Access Compliance Report

Public Rights-of-Way

Intersection ID: 16357	Main Street: MONROE_RD	Cross Street: ROSS_MOORE_AV	Location: SW
ADA ID: F169C4C2062A	Ramp Type: BlendTrans1	Initial Pass/Fail: Pass	Overall Compliance: No
		Severity Score: 15

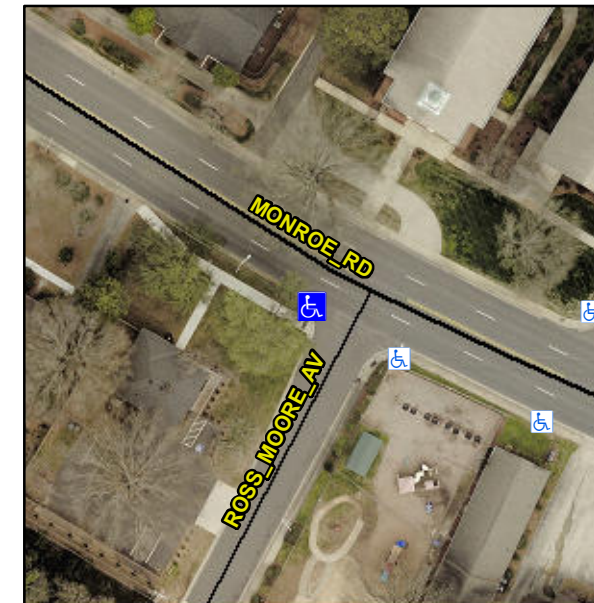
Surveyor Notes:

ASP LIP 1.0

PROW/ADA:

Not Found, R304.2.1, R304.5.3, R302.7.2

Possible Solutions:

Remove & Replace Curb Ramp With Two New Directional Ramps or Equivalent.
